ENGINEERING CHANGE NOTICE

1. ECN 134976L

5. Project Title/No./Work Order No.	6. Bldg./Sys./Fac. No. PUREX	7. Impact Level 2
	8. Document Number Affected (include rev. and sheet no.) SD-HS-SAR-001, Rev. 5	9. Related ECN No(s). N/A	10. Related PO No. N/A
11a. Modification Work <input checked="" type="checkbox"/> Yes (fill out Blk. 11b) <input type="checkbox"/> No (NA Blks. 11b, 11c, 11d)	11b. Work Package Doc. No. 9221005	11c. Complete Installation Work Cog. Engineer Signature & Date	11d. Complete Restoration (Temp. ECN only) Cog. Engineer Signature & Date

SAFETY EVALUATION
PROCESS DISTILLATE DISCHARGE TO TANK FARMS

FIGURE 1: PDD TRANSFER SYSTEM

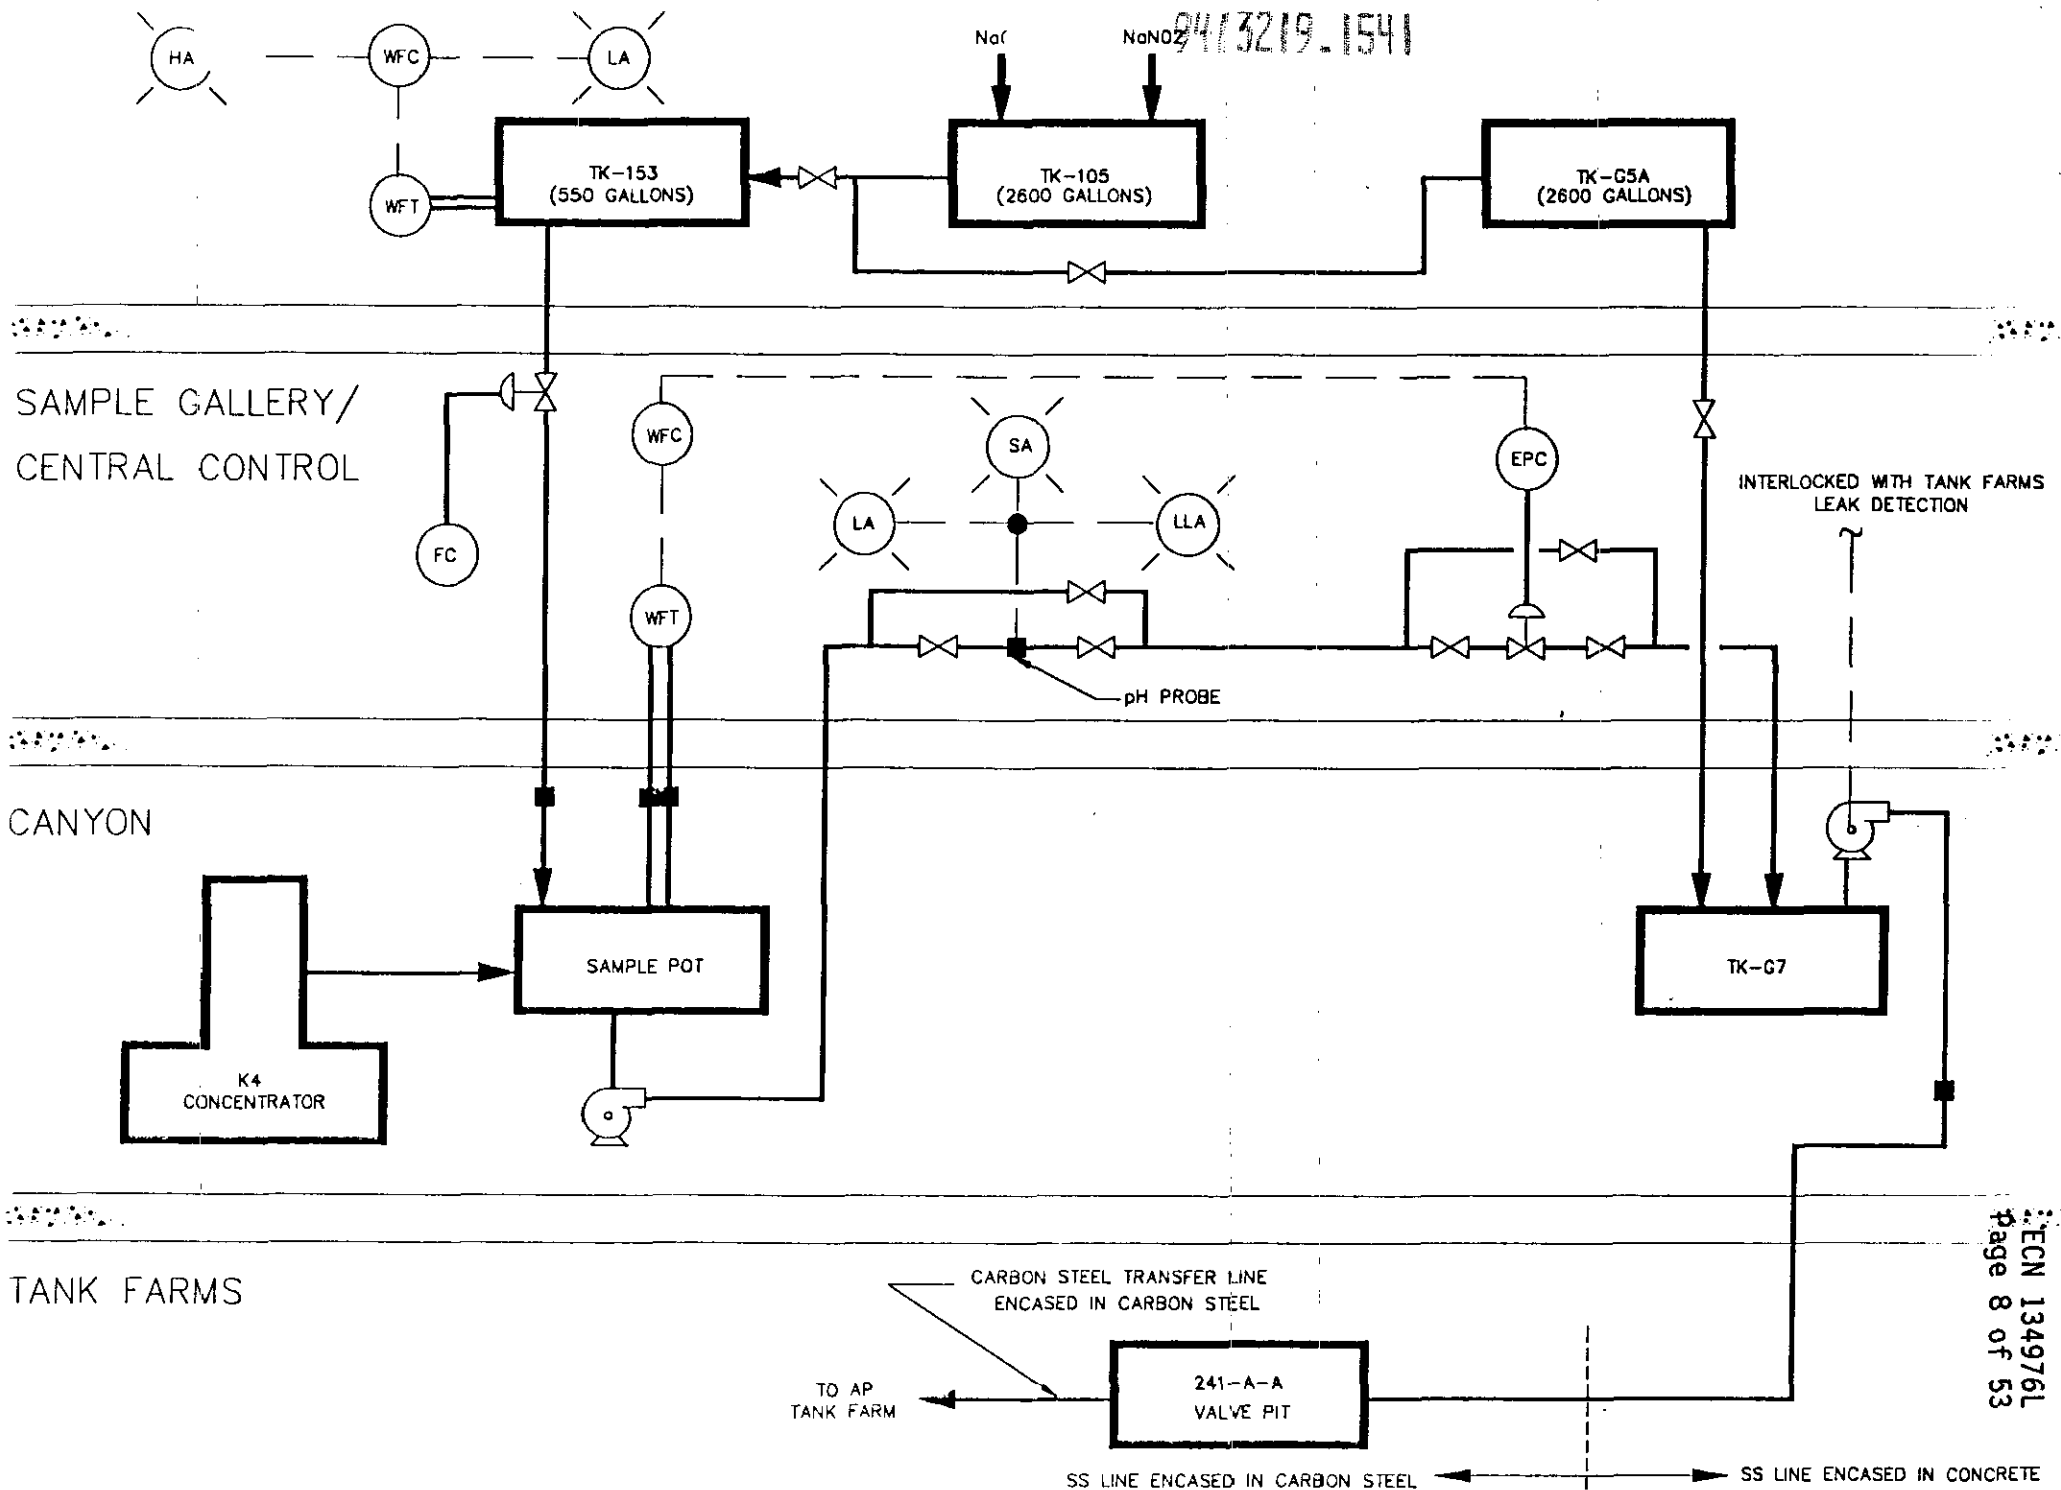
This system will be temporarily modified to route the PDD stream to a 15,000 gallon tank, TK-G7, and then to Tank Farms for storage (Figure 1). The condensate will still be collected in the K4 Sample Pot, but the Sample Pot will now be continuously pumped out of the PUREX canyon through a new route in the PUREX Sample Gallery. This route runs overhead down the Sample Gallery and back into the canyon, where the solution is discharged into TK-G7. The solution is transferred from TK-G7 to Tank Farms using the existing ammonia scrubber feed (ASF) route.

A weight factor control system in the K4 Sample Pot will adjust the PDD flow to maintain a constant level in the Sample Pot. This prevents the transfer pump from running dry.

Sodium hydroxide/sodium nitrite will be added to the K4 Sample Pot to ensure the PDD meets Tank Farm specifications for receipt into mild-steel underground storage tanks (Table 1 and Reference 1). A pH probe on the transfer line will monitor the composition of the PDD. The mixture of sodium hydroxide and sodium nitrite will be made up in aqueous make-up tank TK-105 and transferred to TK-153 where it will be metered into the K4 Sample Pot through an existing control valve. Sodium hydroxide/sodium nitrite will also be added to TK-G5A for batch addition to TK-G7 should the need arise. Tank G7 will be sampled routinely to confirm that Tank Farm specifications are met. These samples will

FIGURE 2: pH CONTROL SYSTEM

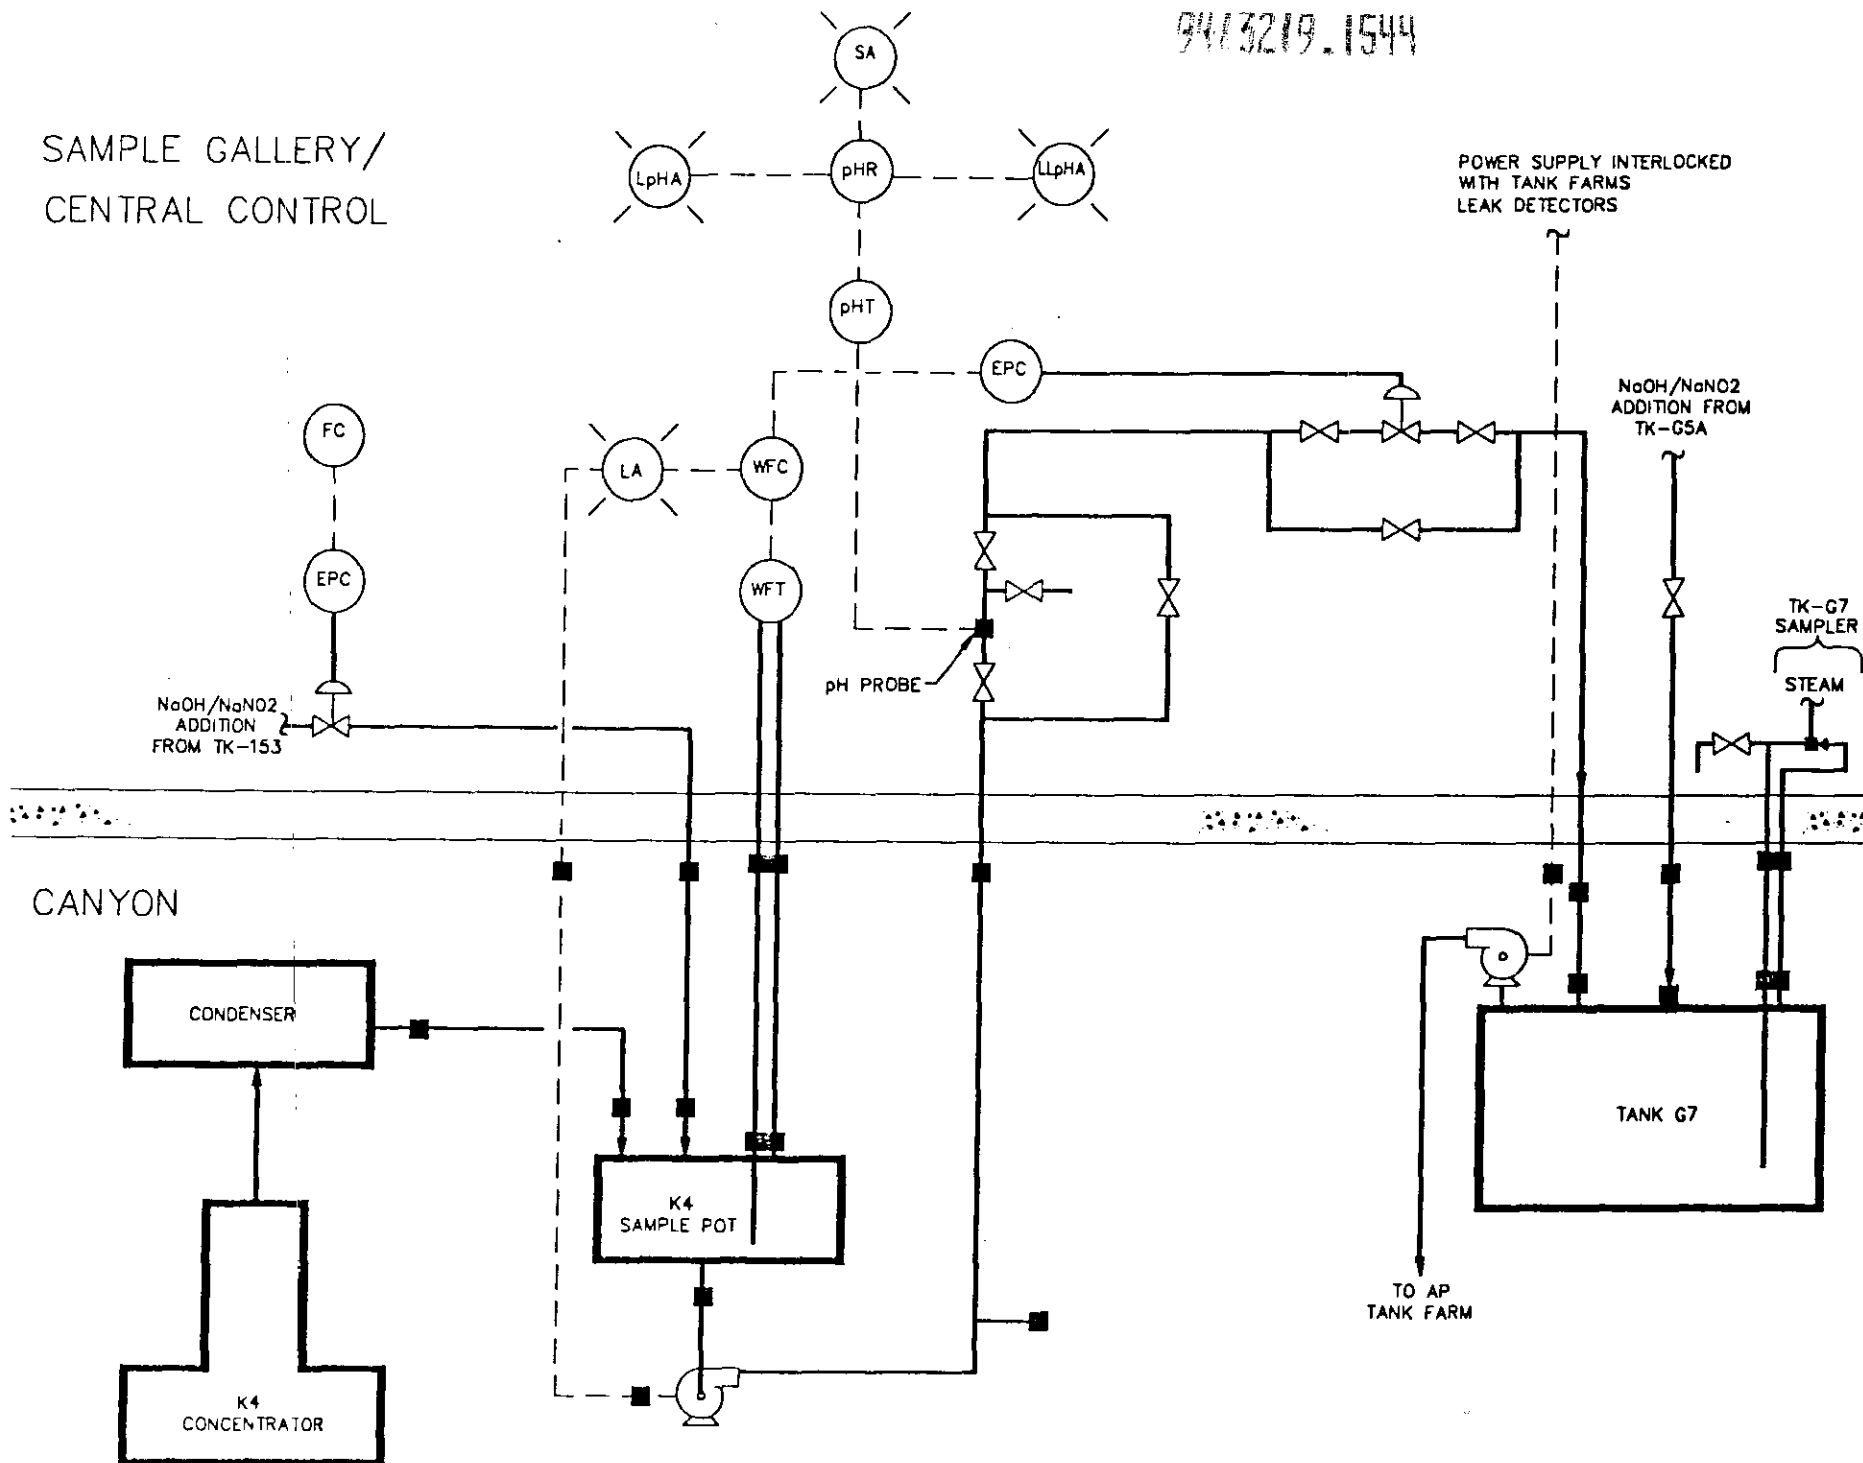
To ensure that the applicable Operational Safety Requirements (OSRs), Limiting Condition of Operations (LCOs), and Limiting Control Settings (LCSs) are met, the following pH control system will be implemented for the PDD to Tank Farms transfer (Figure 2).

A four element system will be used to control/monitor the pH of the PDD being discharged to Tank Farms. These elements are: (1) sodium hydroxide addition to the K4 Sample Pot, (2) an in-line pH probe on the K4 to TK-G7 transfer line, (3) sampling of TK-G7, and (4) sodium hydroxide/sodium nitrite addition to TK-G7. The existing K4 Sample Pot sodium hydroxide addition equipment will be used as the primary pH adjustment system. The position of the flow control valve will be manually controlled by operating personnel based on readings from the in-line pH probe. Sodium hydroxide/sodium nitrite will also be added directly to TK-G7 from TK-G5A as a back-up pH adjustment in response to pH samples and alarms.

The in-line pH probe will serve a dual purpose: (1) as the primary pH control device, and (2) a low pH indicator. This device will be equipped with a low alarm, a low-low alarm, and a safety alarm. The alarms will be set at a pH of 12.0, 11.0 and 10.0, respectively. The reponse/recovery actions for all three alarm conditions are listed in Figure 3.
